Subject: RE: La Crosse County Surveyor - For Review - CSM - Causeway Blvd 17-20251-15

The proposed Causeway Boulevard CSM has been reviewed. See comments below.

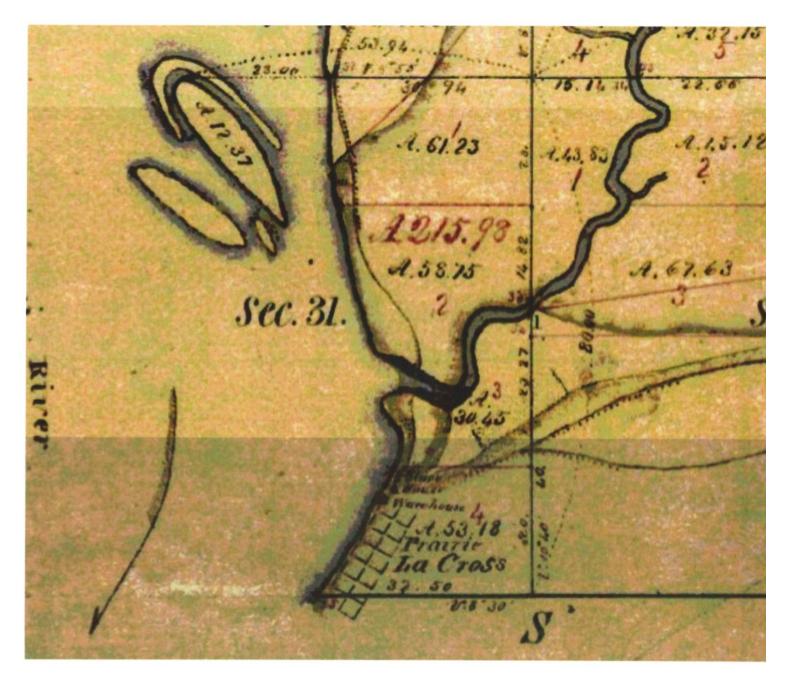
1. The caption on all four pages, along with the opening statement in the legal description states "located in the Northwest ¼ of the Northeast ¼". That statement is incorrect. There is no Northwest ¼ of the Northeast ¼ in Section 31. It is only Government Lot 1 as per the Original Government Plat Sheet (below). I realize that the plat of River Point District indicates that it is part of the Northwest ¼ of the Northeast ¼, but that is simply not true. Register of Deeds, Robin Kadrmas indicates that she only has tracting for Government Lot 1 in this area.
